**Florida
Power**
CORPORATION

Subject: Crystal River Unit 3
Docket No. 50-302
Operating License No. DPR-72

Enclosed is Florida Power Corporation's interim (qualitative) response to Item 2B of Attachment A to your August 21, 1979 letter. The final response to Item 2B is scheduled for February 1, 1980.

Question 3 - Noncondensable Gases

FIGURE 1

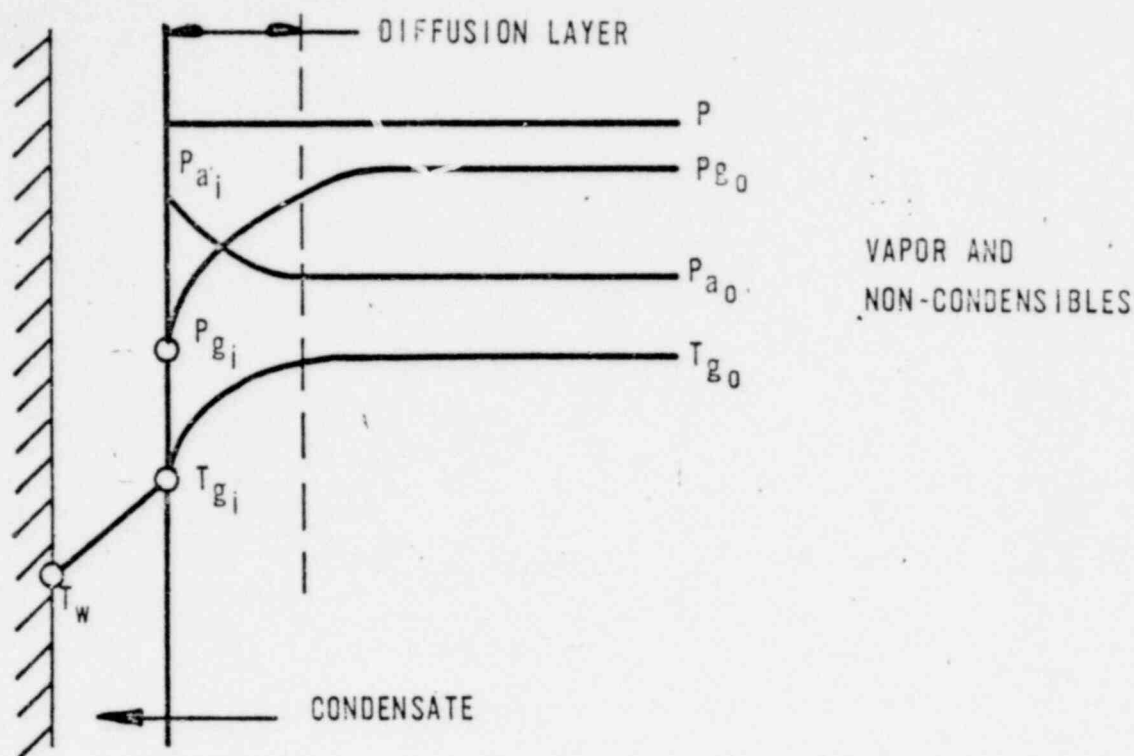
- A. Provide the sources of noncondensable gases in the primary system.
- B. Discuss the effect of noncondensable gases on:
 - (1) condensation heat transfer,
 - (2) system pressure calculations and
 - (3) natural circulation flow.
- C. Describe any operator actions and/or emergency procedures necessary to preclude introduction of significant quantities of noncondensable gases into the primary system.
- D. Describe operator actions to be taken in the event of a significant accumulation of noncondensable gases in the primary system.

The heat transfer during condensation is made up of the sensible heat transferred through the diffusion layer and the latent heat released due to condensation of the vapor reaching the interface (see Figure 1). The model of Colburn and Hougen⁽¹⁾ gives the following equation for the heat transfer in the vapor phase:

For the application to OTSG condensing heat transfer during small break transients, the term $hg(T_{go} - T_{gi})$ can conservatively be neglected since the vapor velocities would be very low. Thus,

The heat transfer with noncondensable gases present is obtained by iteration. An interface temperature T_{gi} is assumed, which fixes P_{gi} , and the heat transfer across the liquid condensate film is computed from

The partial pressure of the gas at the bulk conditions can be calculated from the mole fraction of noncondensable gases. When the heat flux computed from equation 2 matches that computed by equation 3, the proper interface temperature has been found.
